# Access Compliance Report

## Public Rights-of-Way

### (Curb Ramps)

Intersection ID: 28291	Main Street: COMMUNITY HOUSE RD	Cross Street: ARDREY KELL RD	Location: NW
ADA ID: 5D4799059BFD	Ramp Type: Para	Initial Pass/Fail: Fail	Overall Compliance: No
Severity Score: 12.5			
Codes/Mitigation Info/Possible Solution		Field Measurements/Component Compliance

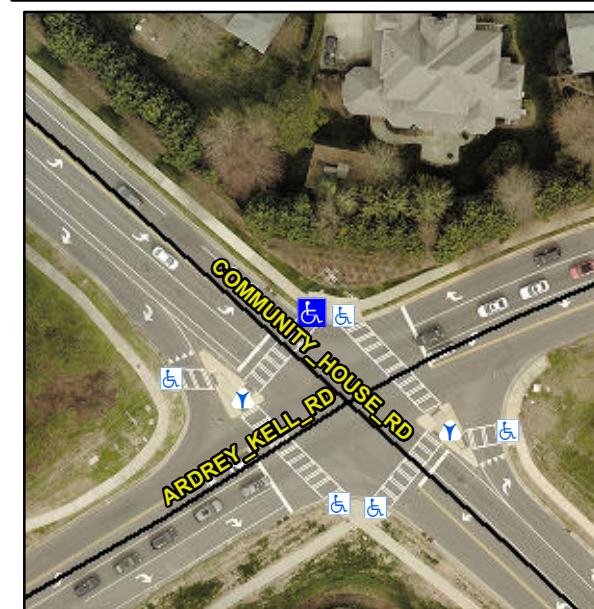
**R304.3.2**

Compliance	Description	Data	Compliance	Description	Data
N/A	Ramp Length LT (in)	57.0	N/A	Ramp Length RT (in)	56.0
Yes	Ramp Width LT (in)	72.0	Yes	Ramp Width RT (in)	72.0
No	Ramp Slope LT (%)	10.6	Yes	Ramp Slope RT (%)	7.1
Yes	Ramp XSlope LT (%)	0.9	Yes	Ramp XSlope RT (%)	0.9
N/A	Landing Length (in)	N/A	N/A	DWS Provided?	N/A
N/A	Landing Width (in)	N/A	N/A	DWS Contrast?	N/A
N/A	Landing Slope (%)	N/A	N/A	DWS Length (in)	N/A
N/A	Landing X Slope (%)	N/A	N/A	DWS Full Width?	N/A
N/A	Landing Curb? (Y/N)	N/A	N/A	DWS Offset (in)	N/A
N/A	Shared Landing?	N/A			
N/A	Gutter Ponding?	N/A	N/A	Gutter Slope (%)	N/A
N/A	Gutter Lip Ht (in)	N/A	N/A	Gutter X Slope (%)	N/A
N/A	Painted X Walk1?	Yes	N/A	Painted X Walk2?	N/A
	X Walk 1 Direction	To SW		X Walk 2 Direction	N/A
N/A	X Walk 1 Width (in)	112.0	N/A	X Walk 2 Width (in)	N/A
	X Walk 1 Slope (%)	2.5		X Walk 2 Slope (%)	N/A
	X Walk 1 X Slope (%)	0.6		X Walk 2 X Slope (%)	N/A
N/A	Ramp inside XWalk1?	Yes	N/A	Ramp inside XWalk2?	N/A

**Remove & Replace Entire Ramp.**
